DATE: June 19, 2015
 TO: Planning Commission
 FROM: Stacey Fedewa, Planning & Zoning Official
 RE: Site Plan Review – Transfer Tool Parking Lot Expansion

SITE PLAN REVIEW APPLICATION

ADDITIONAL PARKING FOR
TRANSFER TOOL
 14444 100TH AVE GRAND HAVEN, MI

SITE PLAN
 SCALE: 1" = 40'-0"

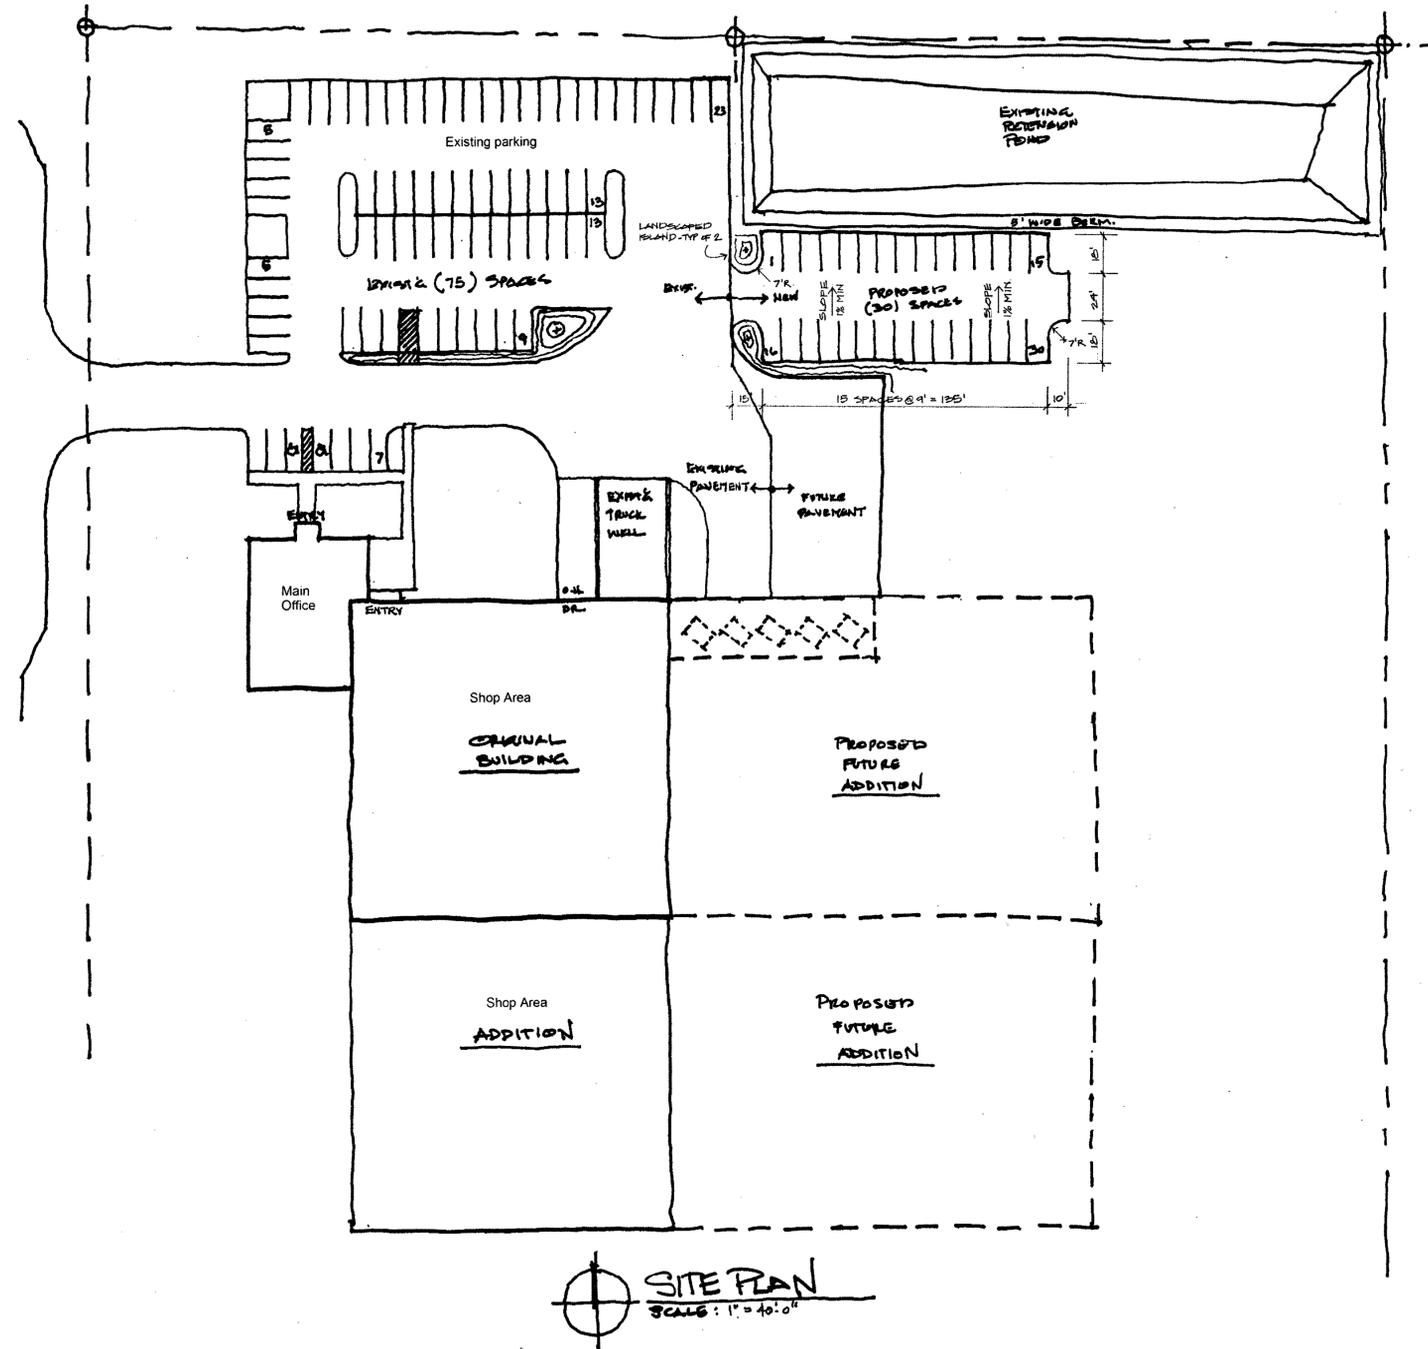
The proposed 90° spaces meet the parking standards found in Section 24.04:

1. Maneuvering Lane Width = 24 feet
2. Parking Space Width = 9 feet
3. Parking Space Length = 18 feet

The total size of the impervious surface addition is 8,720 square feet, which does not reach the threshold of 10,000 square feet (*requires the installation of interior landscaping*). The applicant does not propose any outdoor lighting.

Utilizing the Schedule for Number of Off-Street Parking Spaces, the maximum number of spaces on the Transfer Tool site is 63 spaces. Currently, there are 75 on the existing site. The proposed addition will bring the total number of spaces to 105.

Per Section 24.03.1 – the **number of parking spaces shall not exceed the amount permitted unless approved by the Planning Commission based on a parking needs study submitted by the applicant.**

At this time staff has inquired why 75 spaces is insufficient; how the applicant determined an additional 30 spaces will meet their needs; and explained a parking needs study is needed for the Planning Commission’s review. A study has not been received; therefore, staff anticipates the applicant will provide the information at the Special Planning Commission meeting.

The Planning Commission must decide if the information presented by the applicant warrants a parking lot addition that exceeds the schedule outlined in Section 24.03 of the Zoning Ordinance. Therefore, the Planning Commission may **choose between the following two motions:**

Motion to approve with conditions the Site Plan Review application for the Transfer Tool Products parking lot addition located at 14444 168th Avenue, based on the application meeting all the requirements of the Grand Haven Charter Township Zoning Ordinance. The approval is conditioned upon receipt of a permit from the Ottawa County Water Resources Commissioner.

Motion to deny the Site Plan Review application for the Transfer Tool Products parking lot addition located at 14444 168th Avenue because the applicant did not submit a parking needs study to justify the request to exceed the required number of parking spaces found in Section 24.03 of the Grand Haven Charter Township Zoning Ordinance.
